IFB Addendum #2 San Mateo County Harbor District Oyster Point Marina Entrance Nav Aids Replacement Project

CONTRACT NO. 2020-04

Questions, Clarifications, Requests for Modifications

Date: September 24, 2021

PROJECT NO: 21S046.00
SHEET NUMBER
S-102

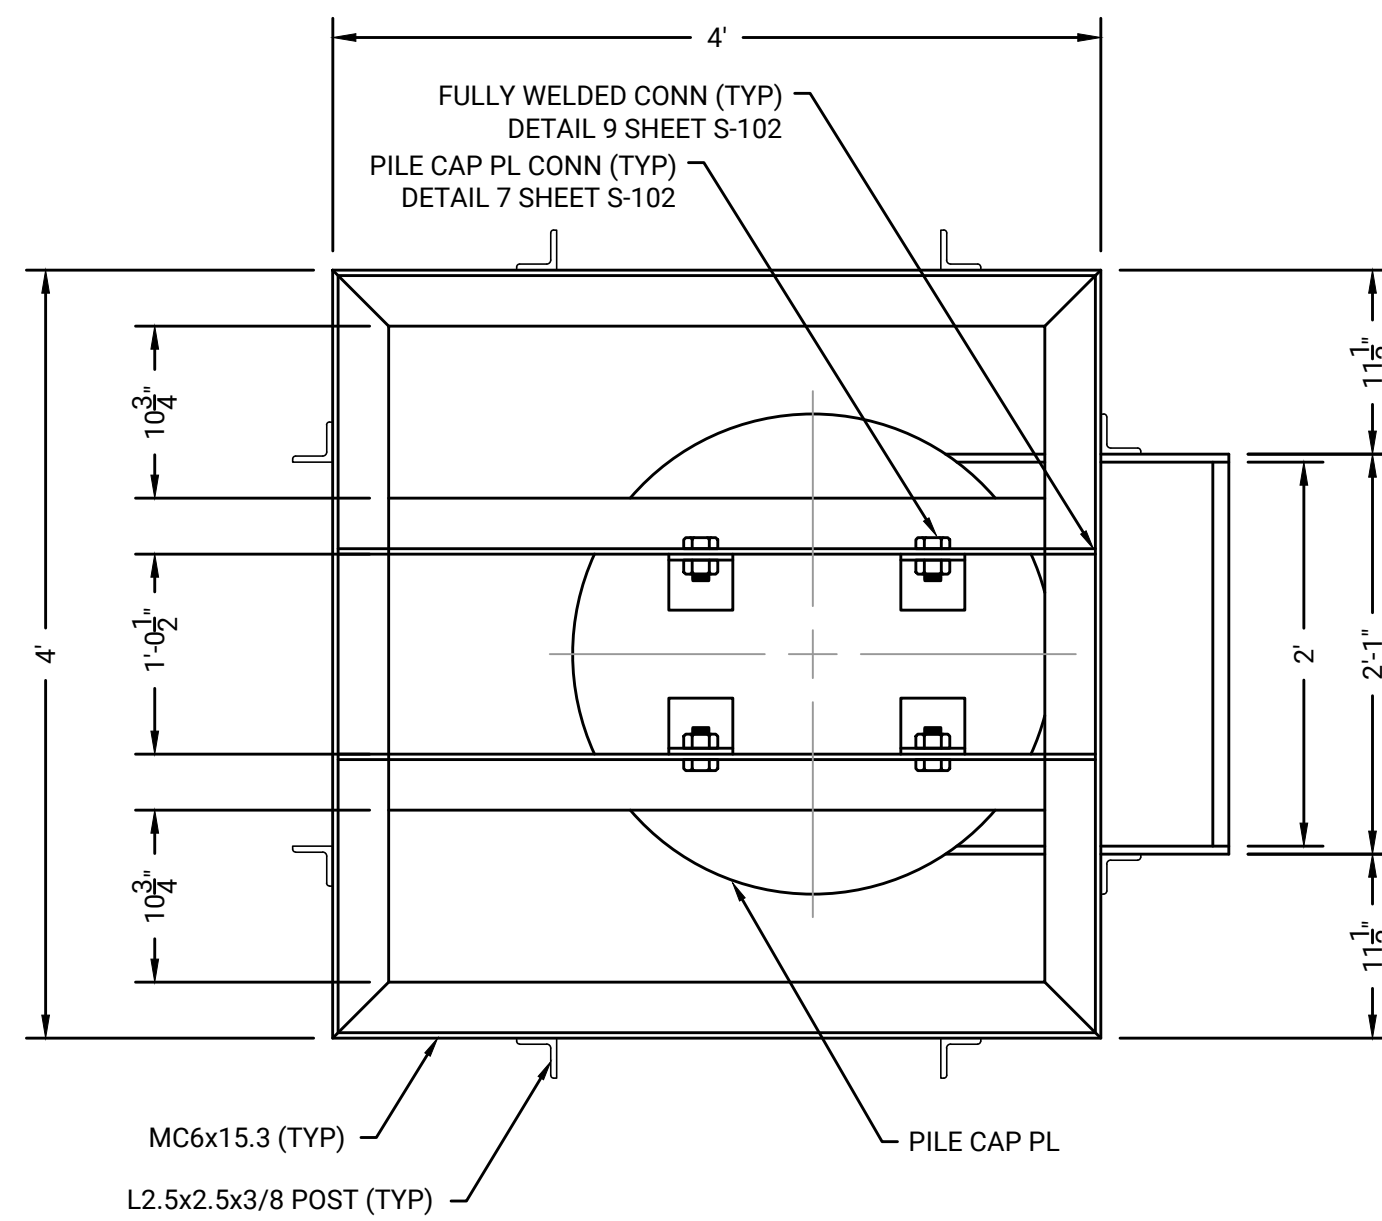
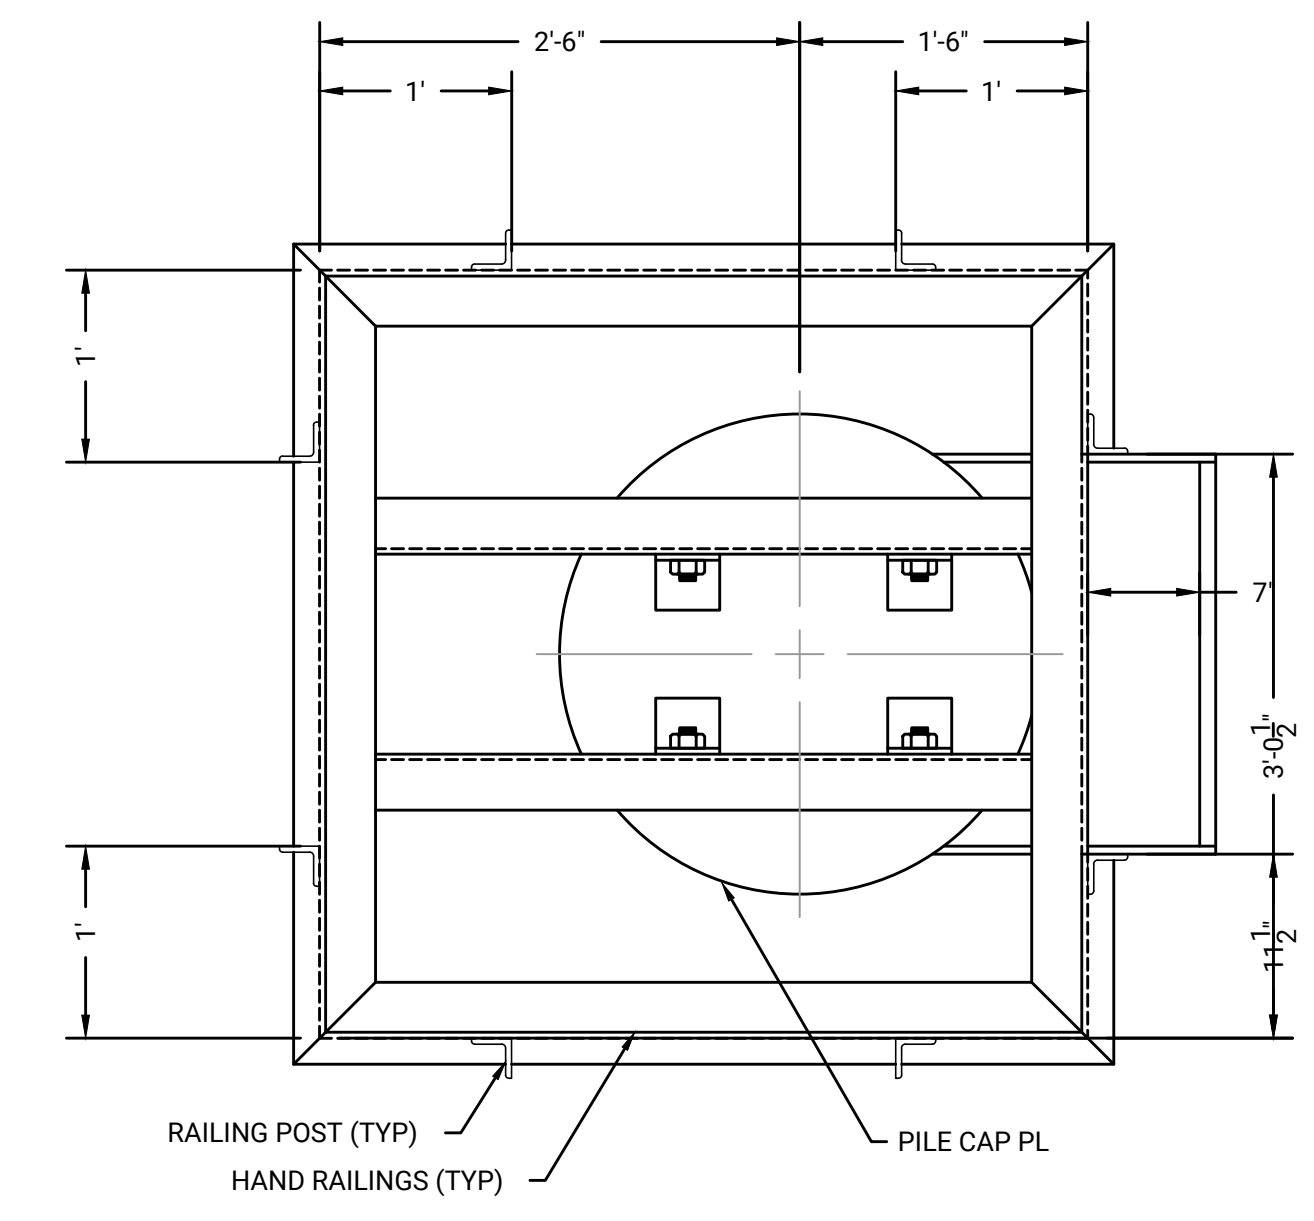
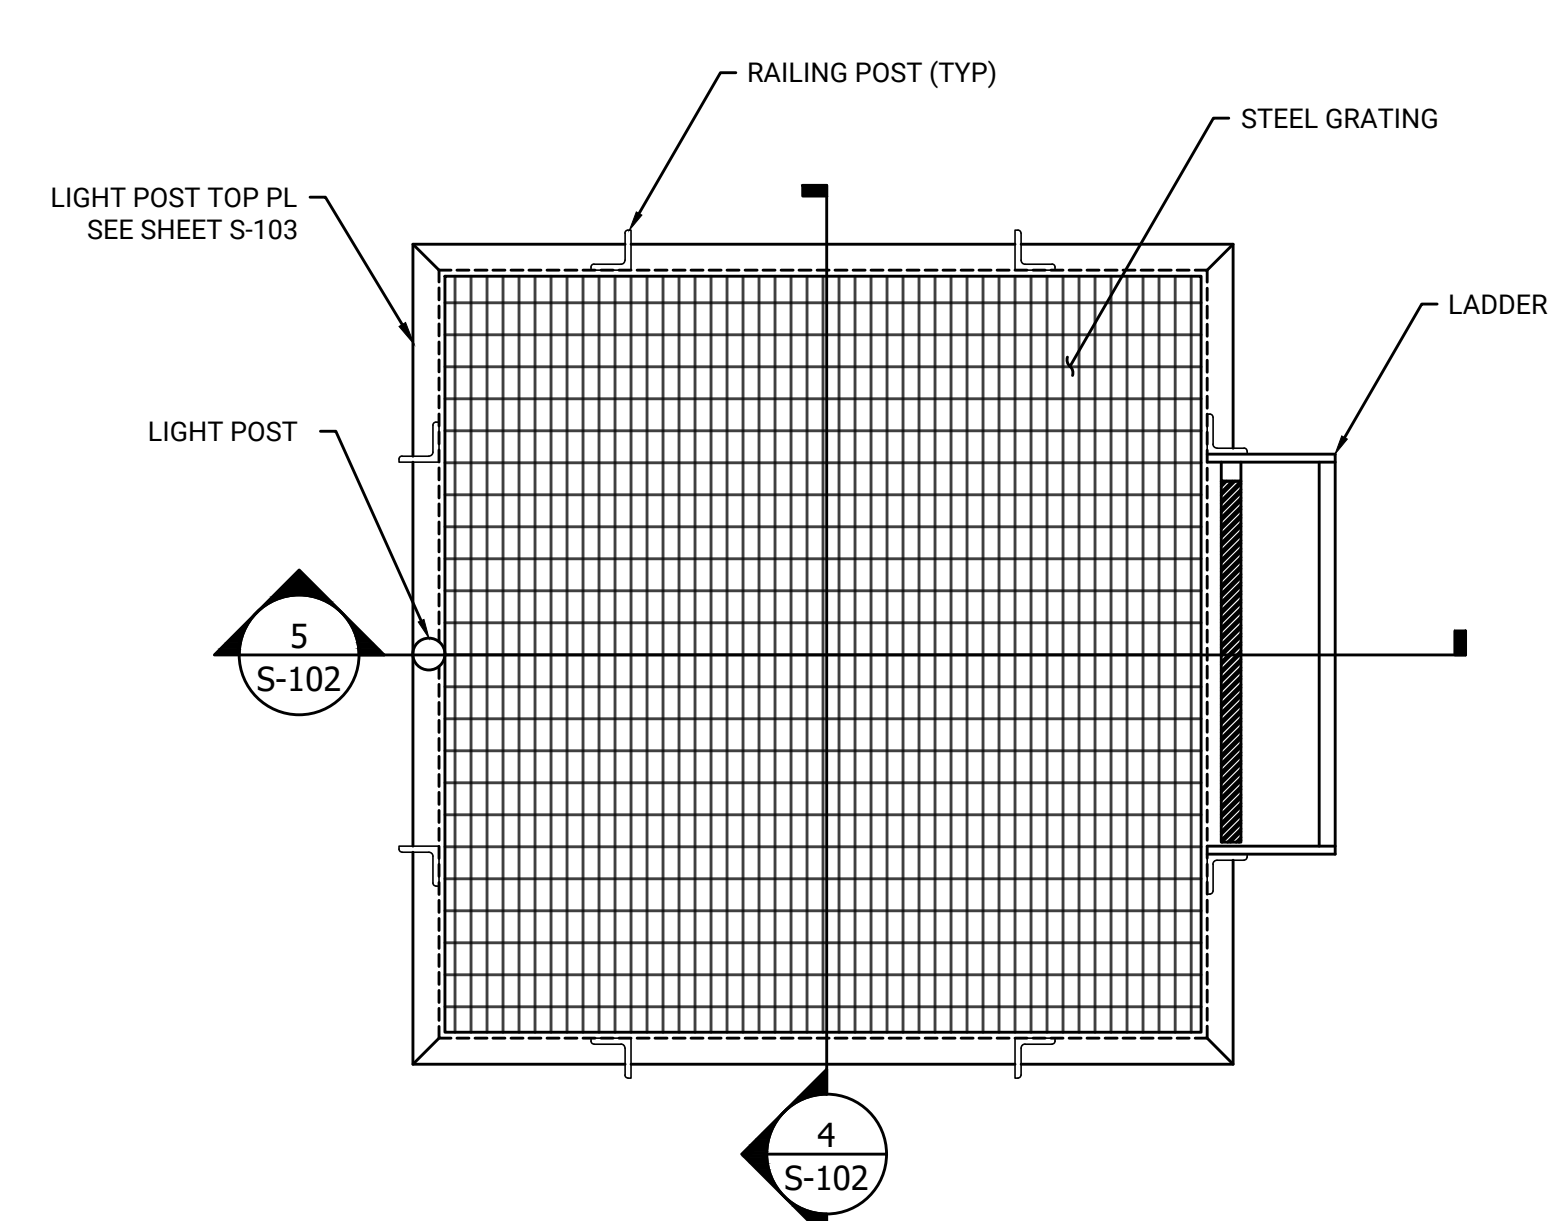
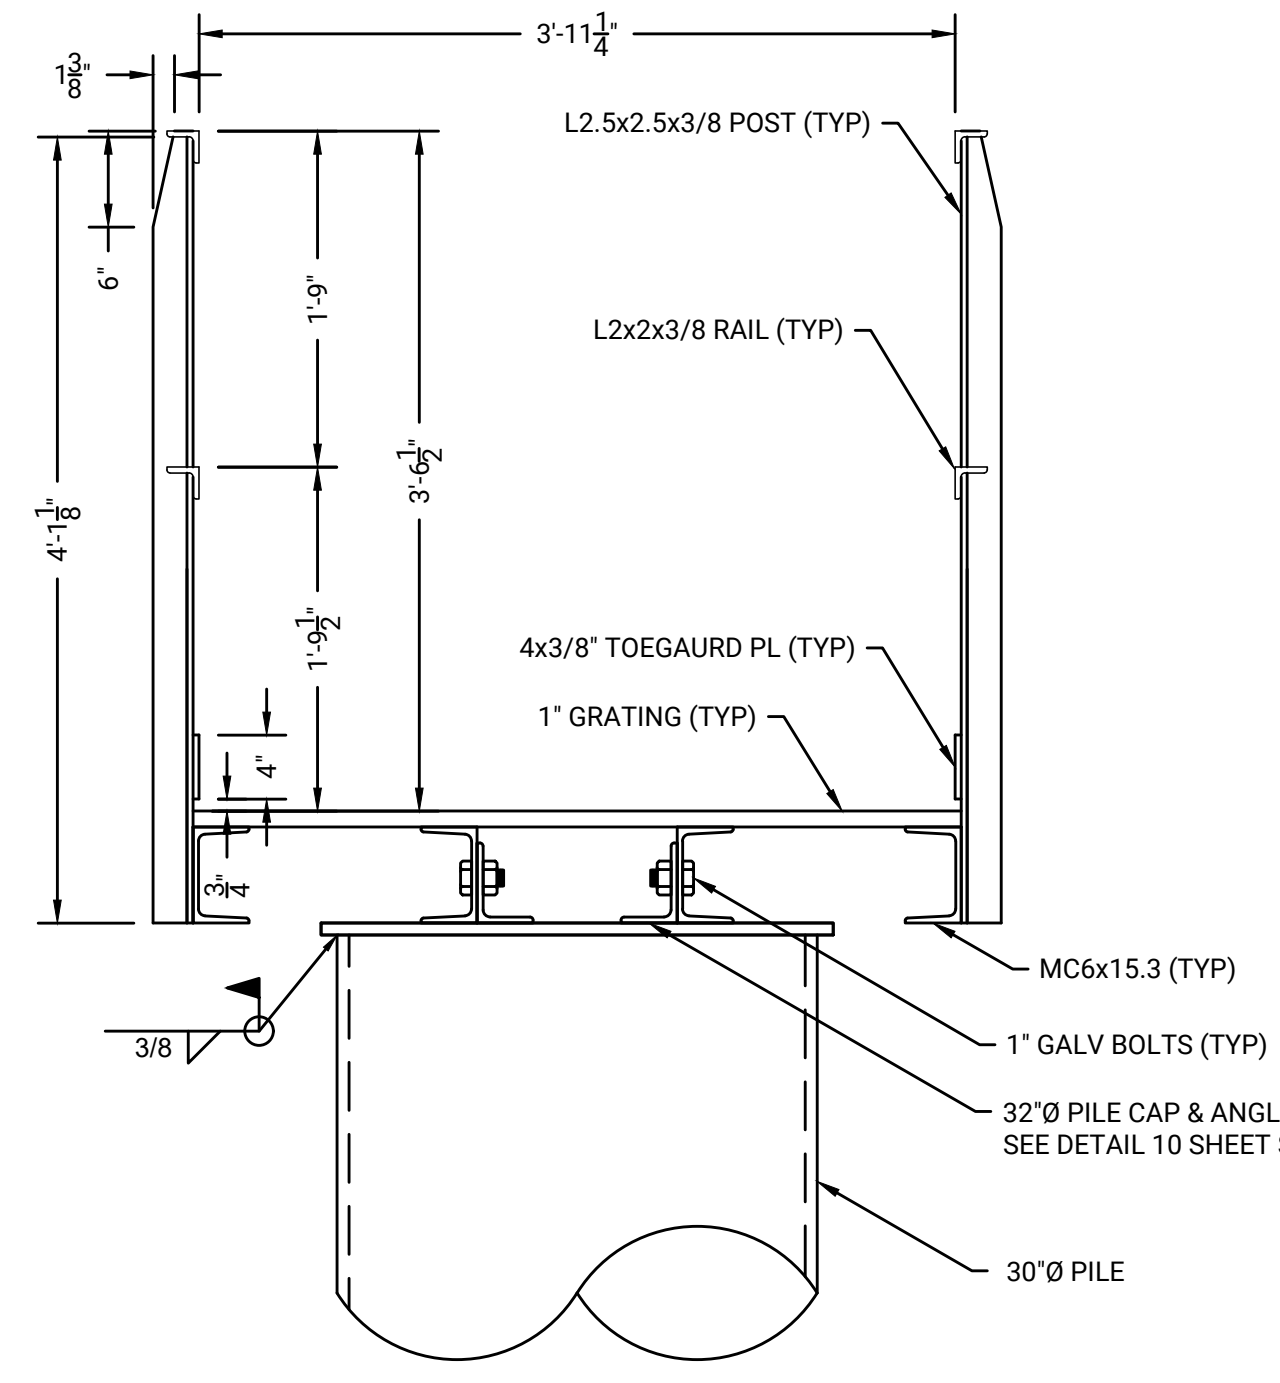
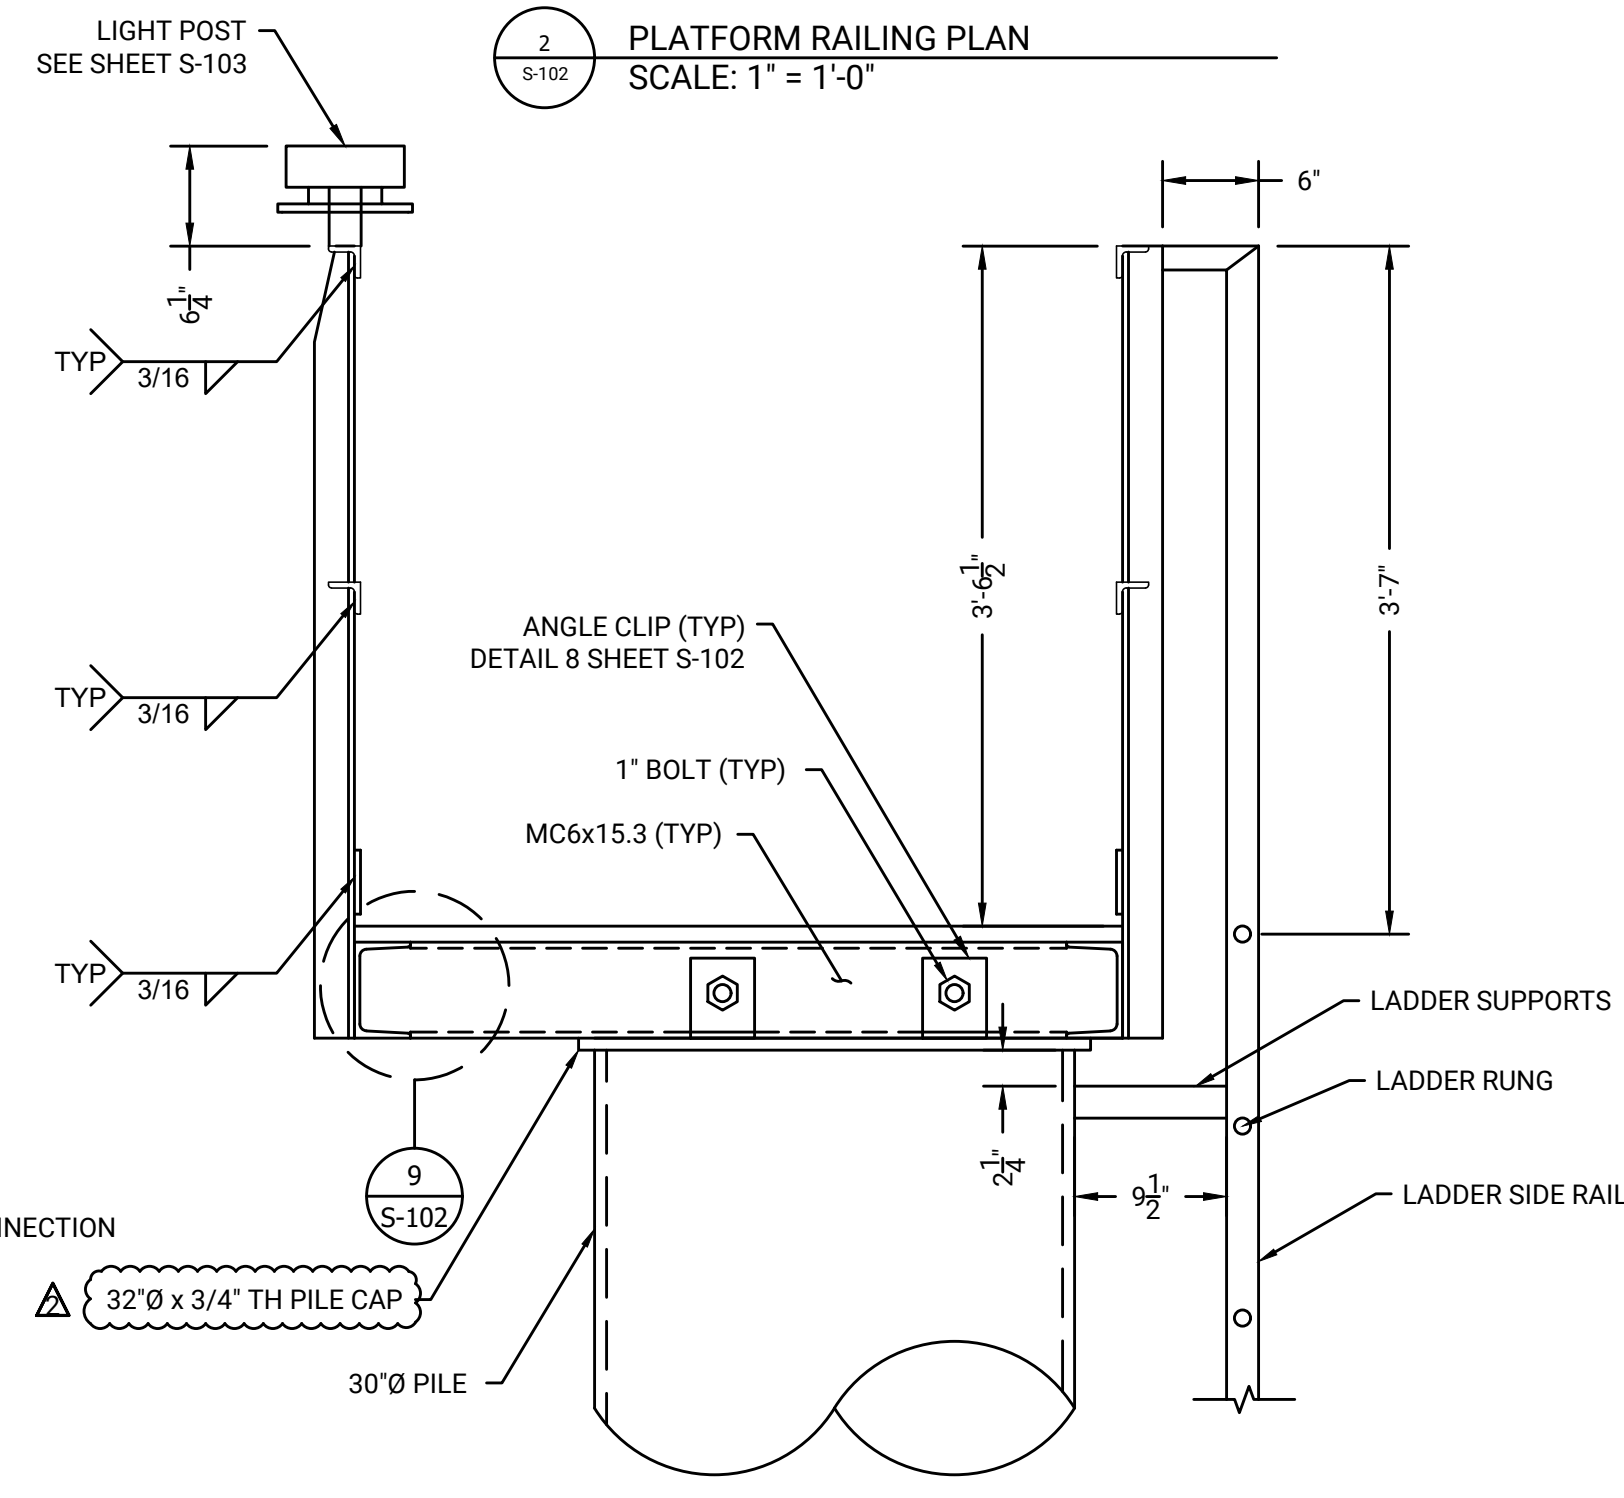
Q13: How are the ladder rung attached? Are they welded, bolted?

Q14: What is the thickness of the pile cap shown on sheet S-102?

A13: Ladder rungs shall be welded.

A14: Pile cap is 0.75 inches thick.
